CHANGE ORDER

CO No.
03

Project Name: Hosmer & Cunniff Elementary Schools

Change Order #03
11/11/2020

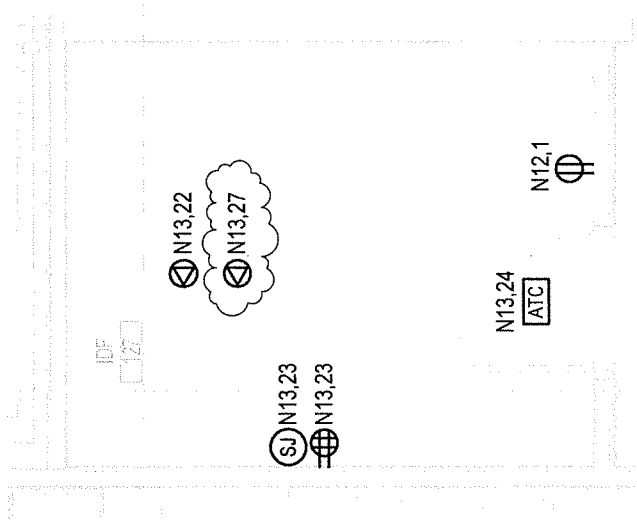
Description: See attached for sketches for a receptacle missed in IDF 127.

Attachments: *(Insert listing of documents that support description.)*
CSKE-026, CSKE-027, CSKE-028, CSKE-029

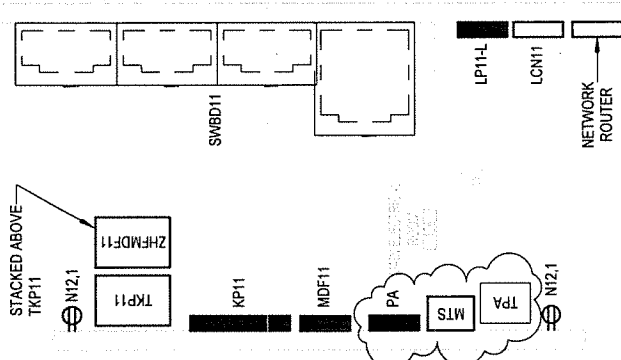
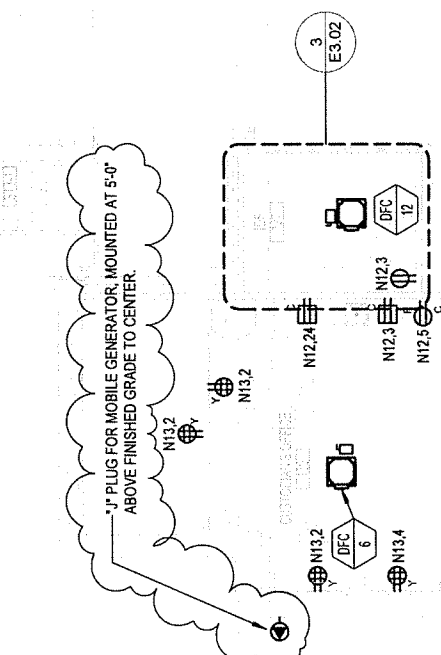
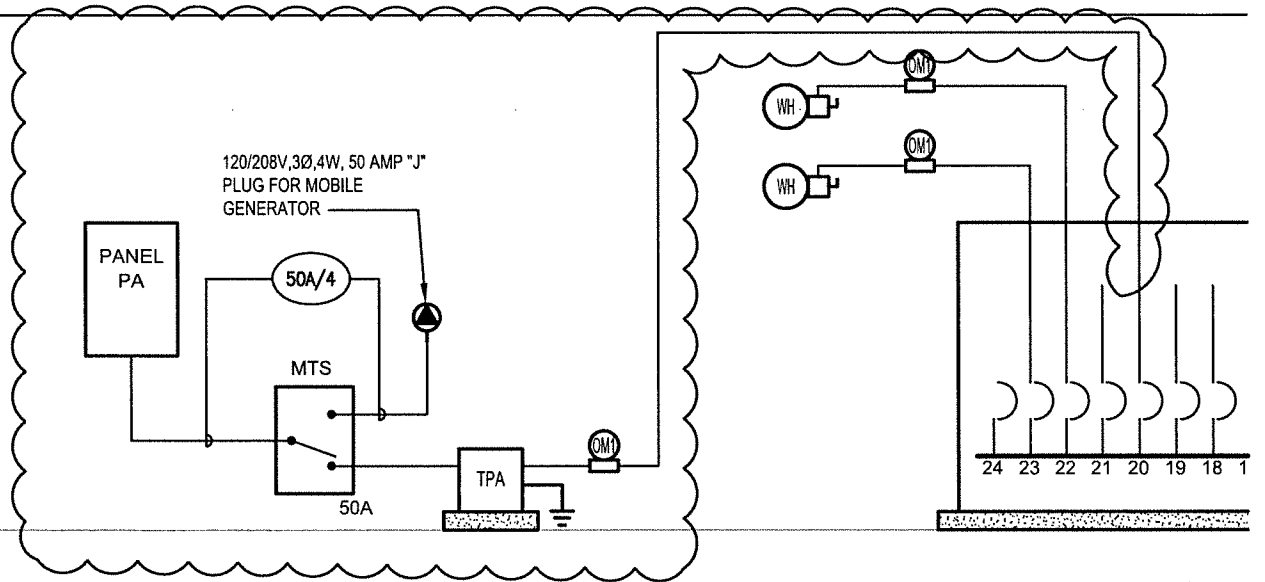
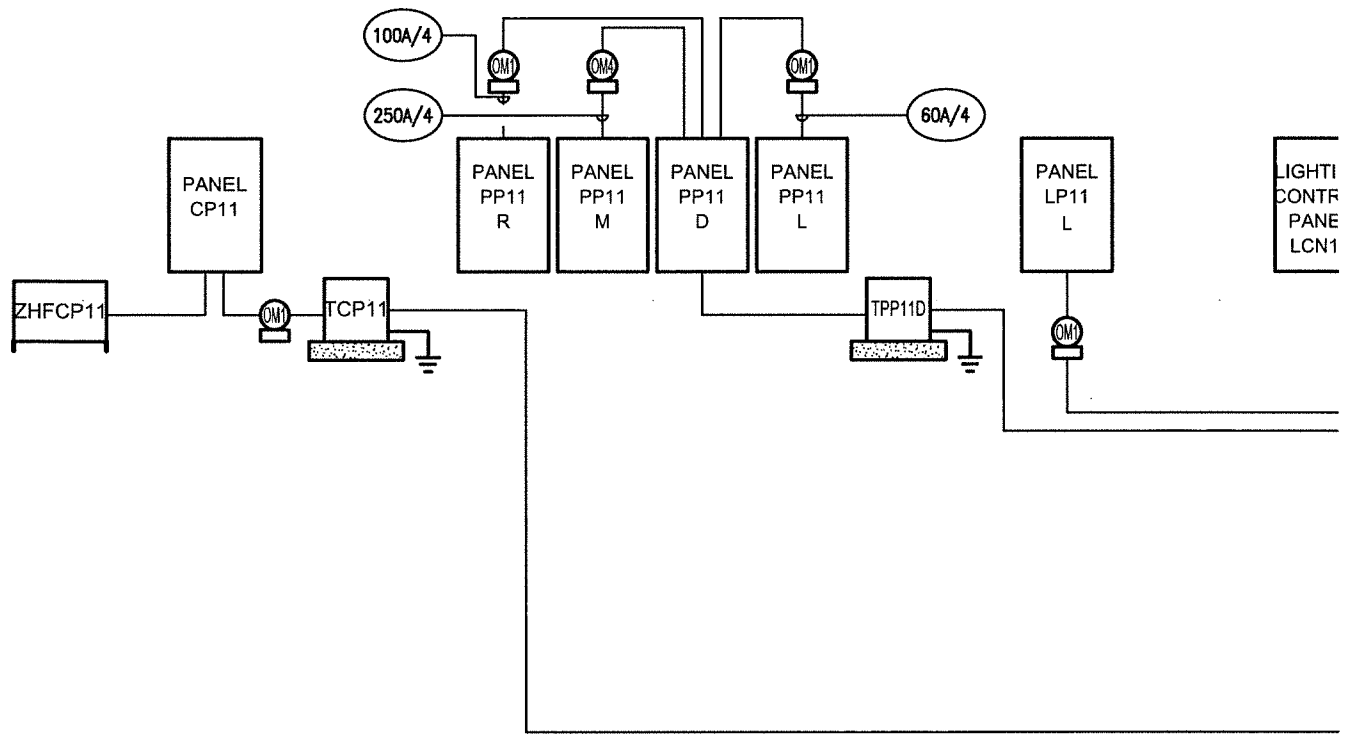
Description: Refer to attached electrical sketches for modifications as it relates to the public safety booster system.

1. PROVIDE WEATHERHEAD ON ROOF ABOVE BDA SHAFT FOR ANTENNA CABLING BEING PROVIDED BY OTHERS.

PROJECT NAME: **HSKFP-003**
FIRE PROTECTION
FIRST FLOOR
PLAN
ZONE 2

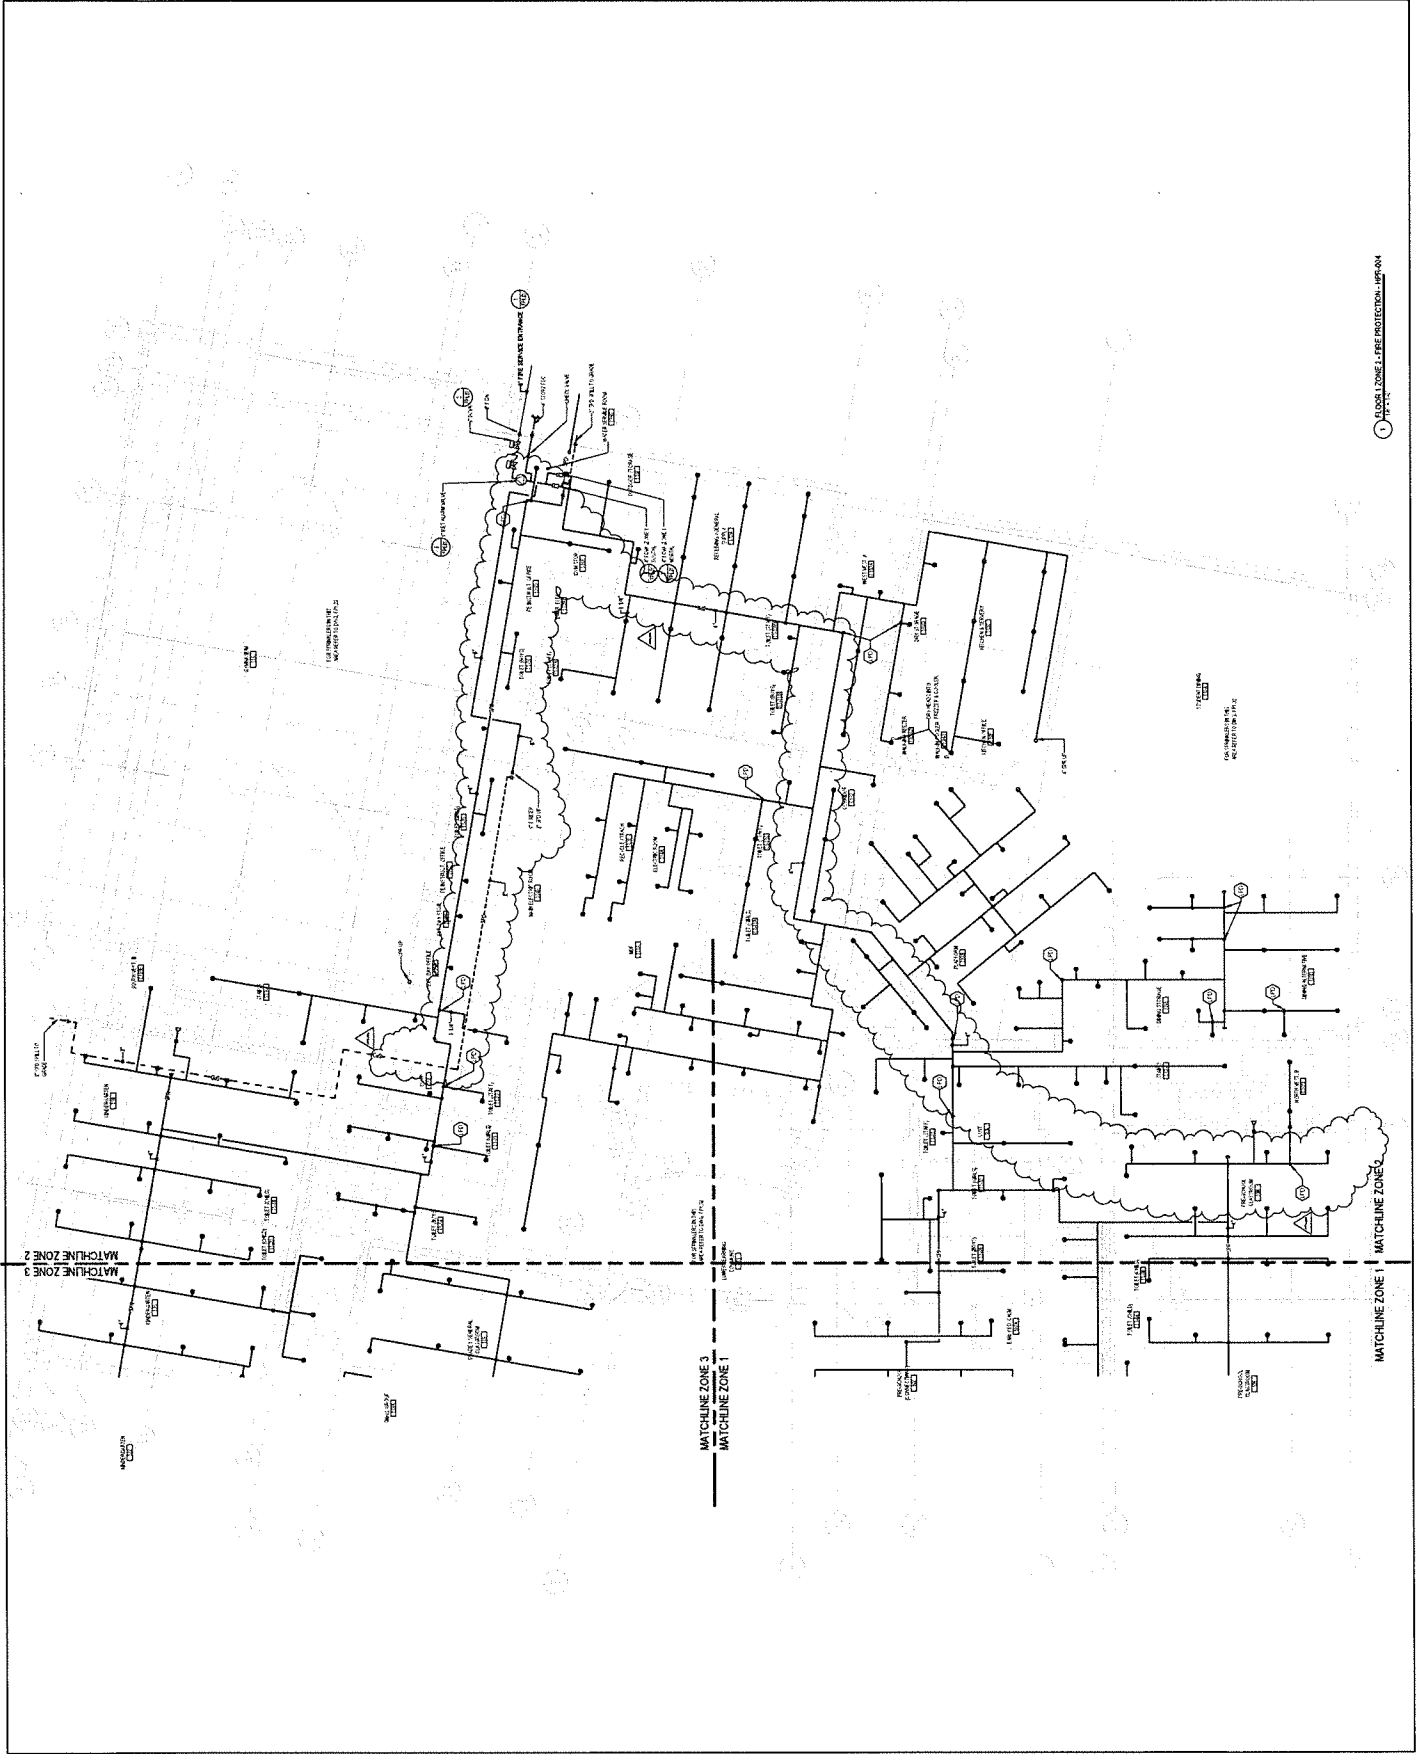
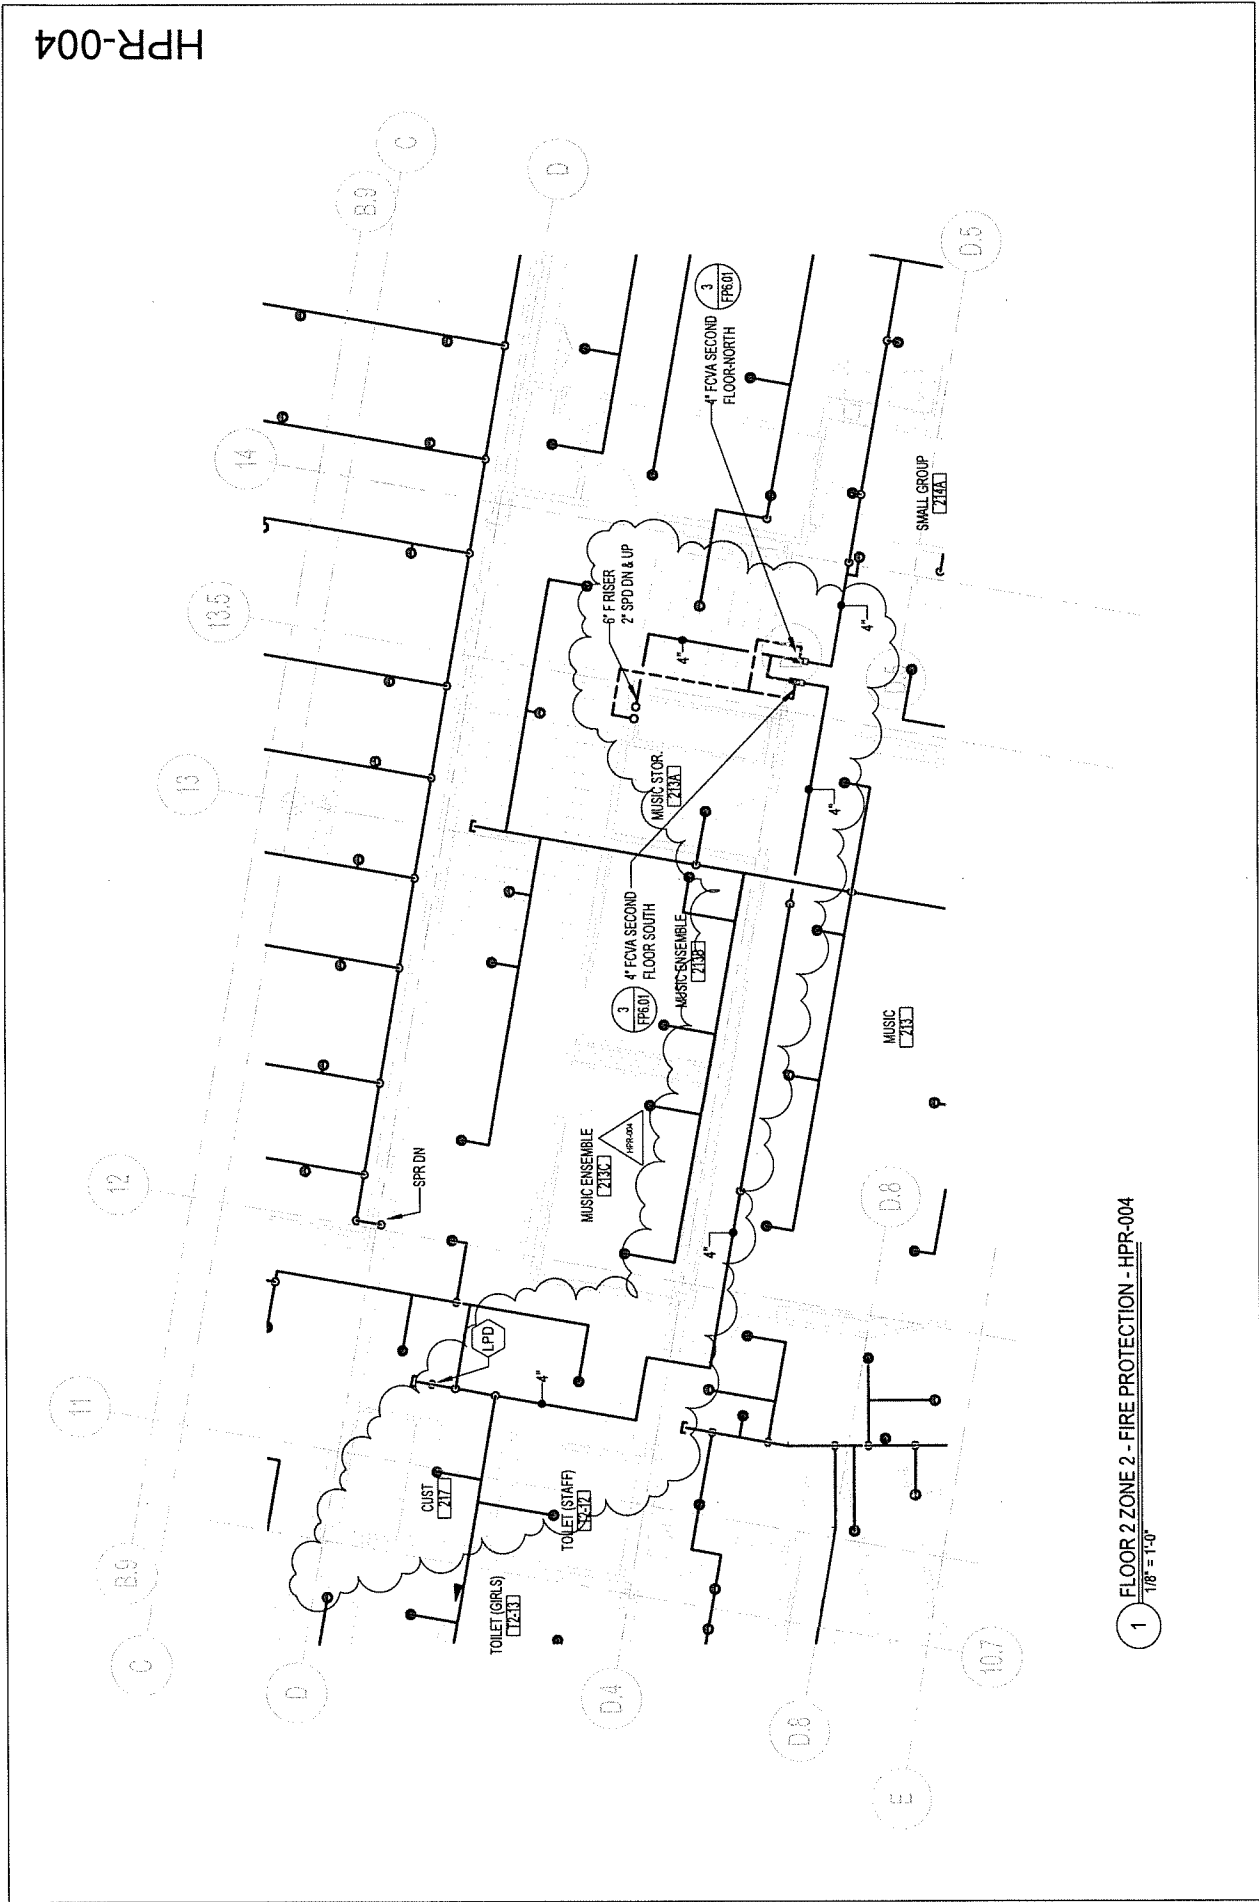
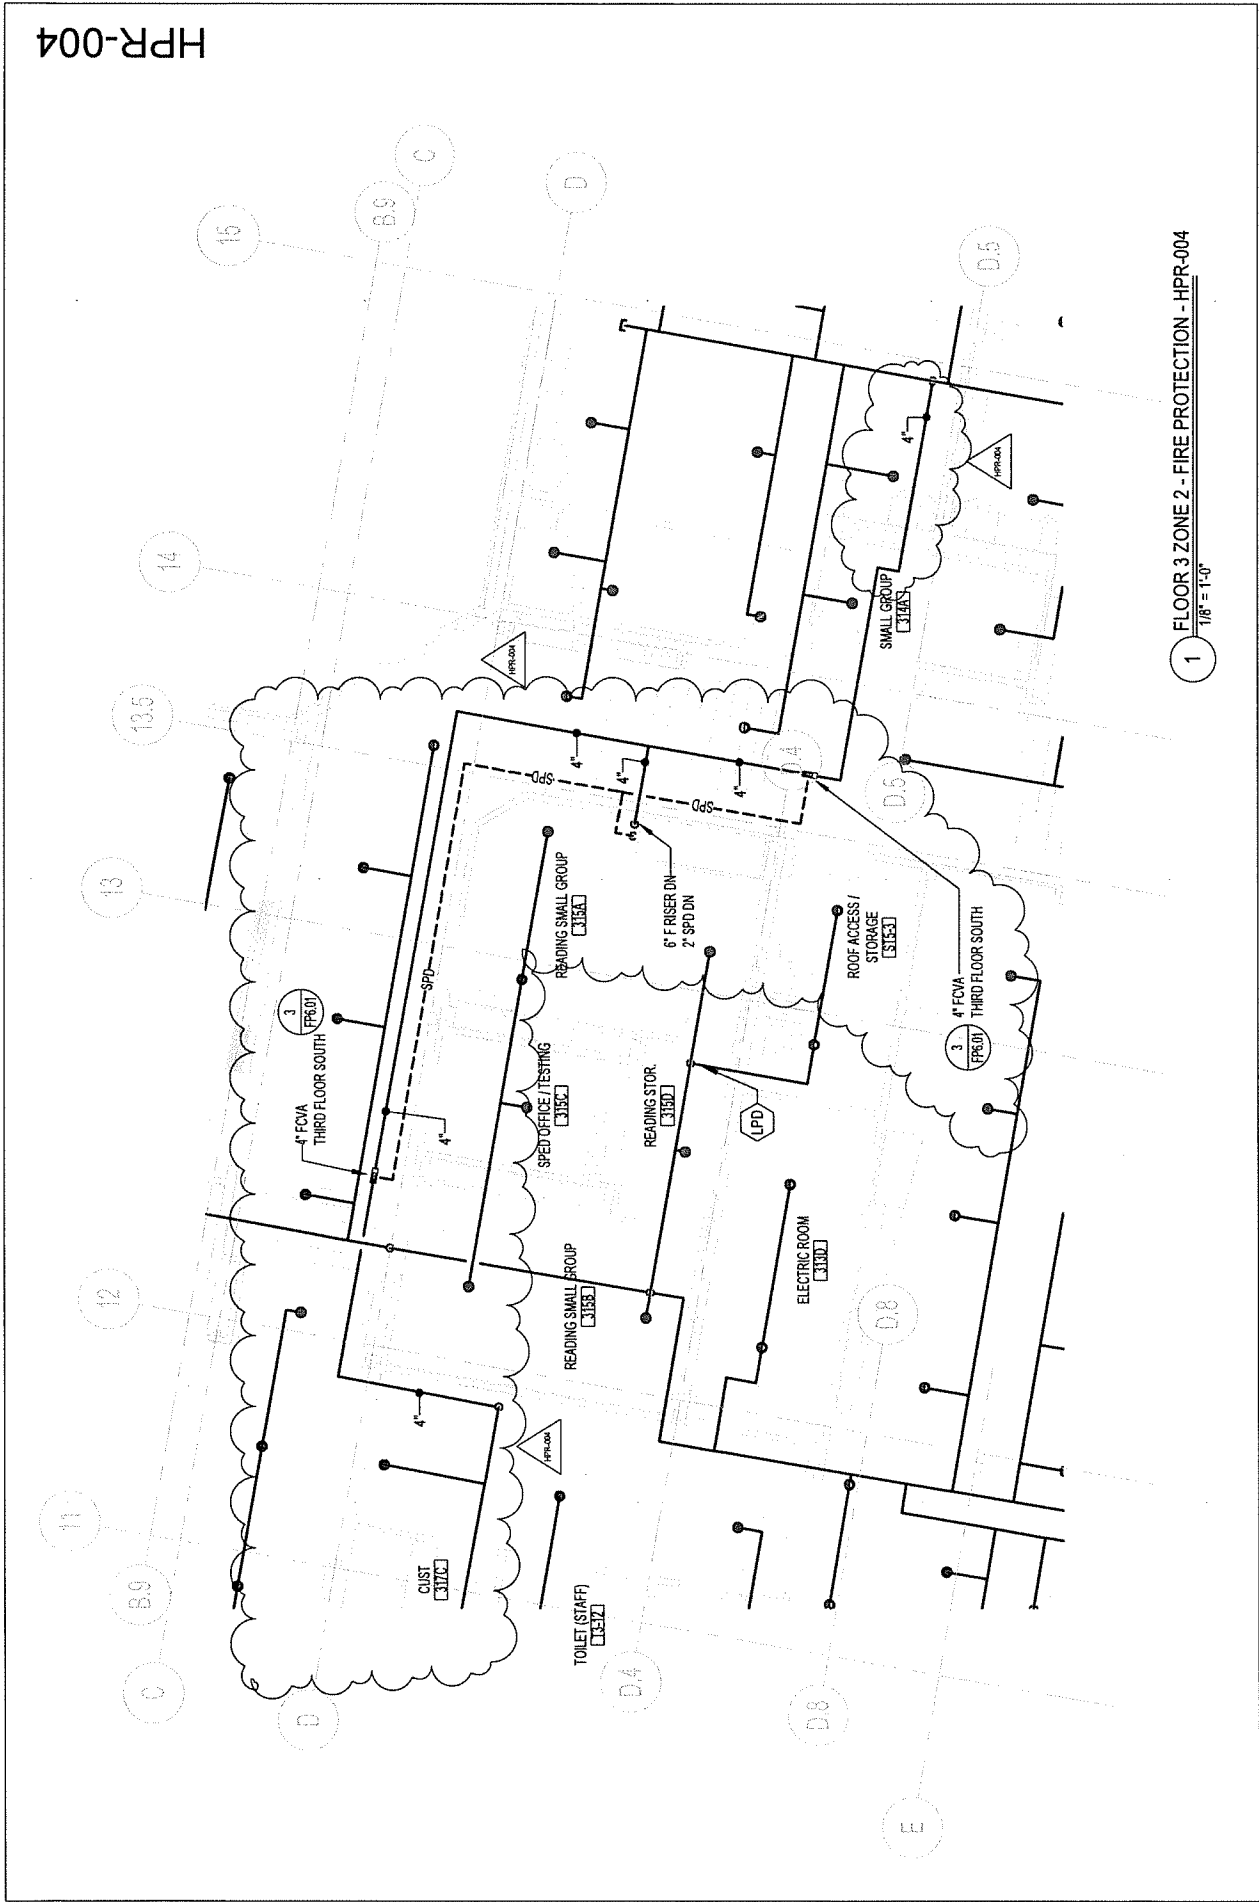
Description: Revised sketches related to the proposed costs of HPCO-001 which include a rerouting of the fire protection sprinkler main.
